KING SOOPERS #49 FUEL SITE
SITE PLAN AND CONDITIONAL USE
BUCKEYE SUBDIVISION FILING NO. 1

DES. BY	DATE	DRAWN BY	DATE
ER	MAR. 7, 2017		
REVISION	NO.	REVISION	DATE
MINOR AMENDMENT- TRASH ENCLOSURE ADDITION

KING SOOPERS
FUELING FACILITY #49
SITE PLAN AND CONDITIONAL USE

COVER SHEET

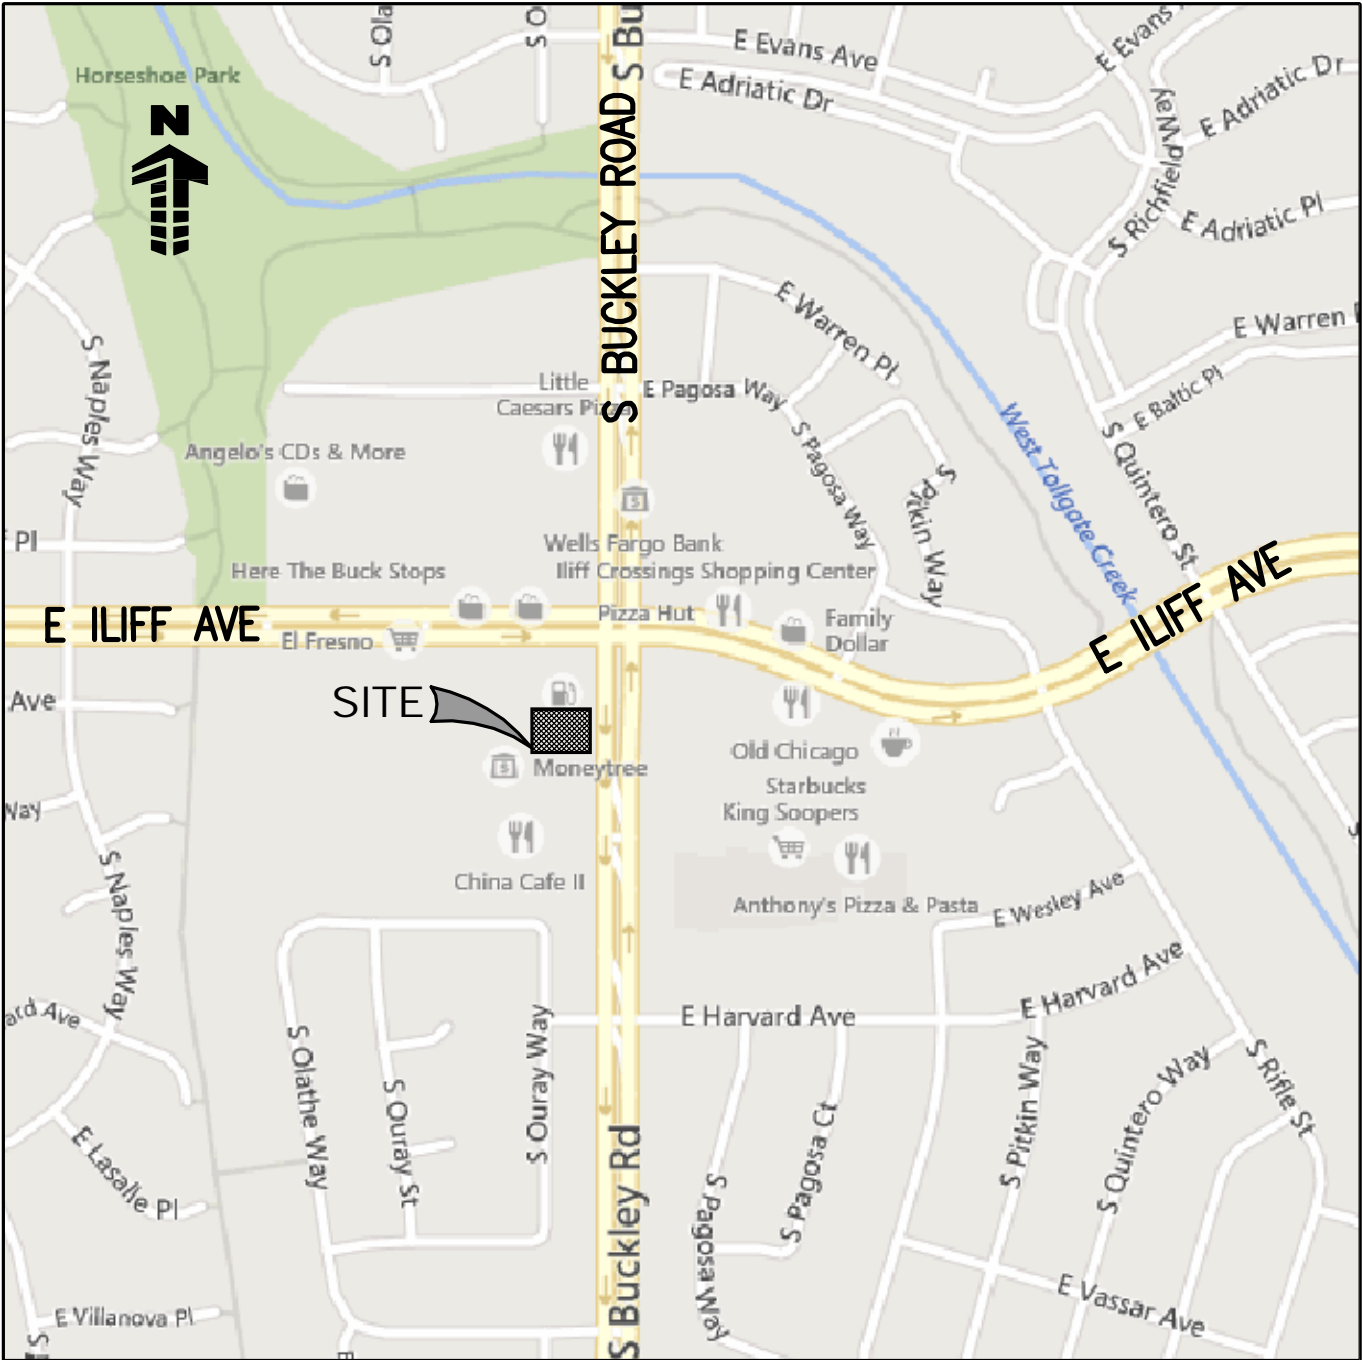
Please upload
New Sheet 8 of 8.
SITE DATA

SITE PLAN

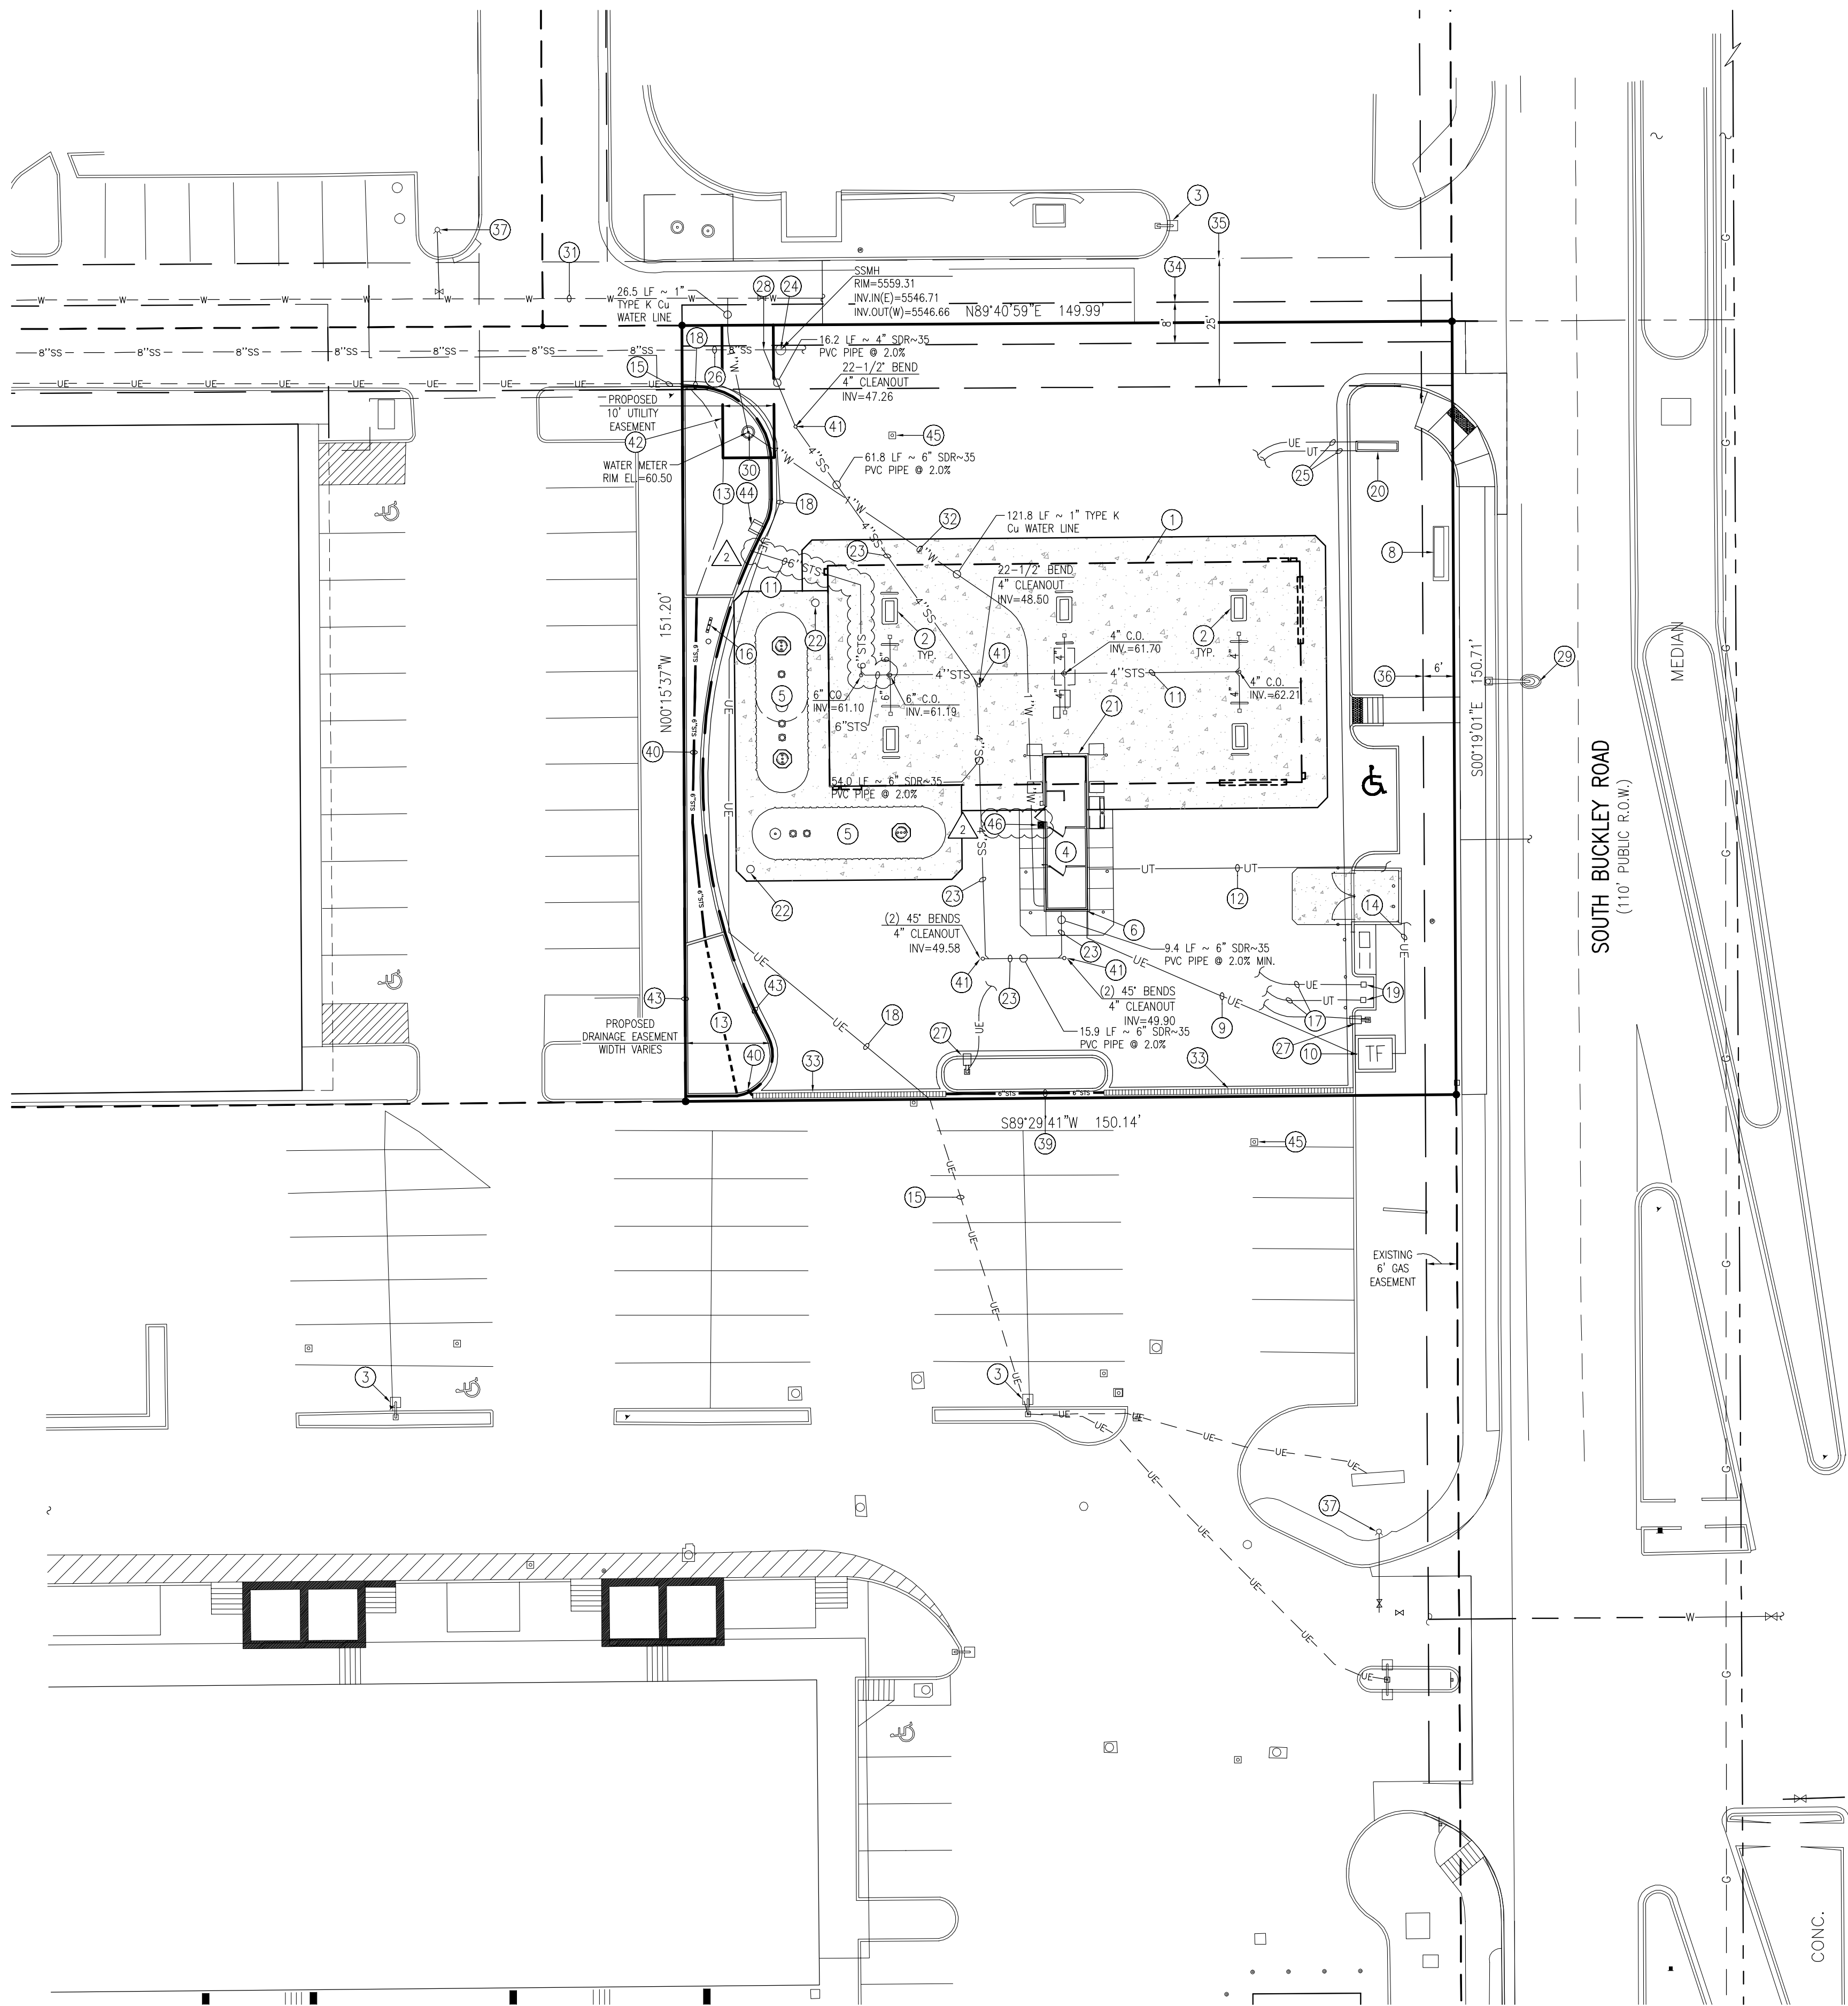
Ramp should be directional per latest COA standards

add stop bar and
stop signs
(consistent with
north side)
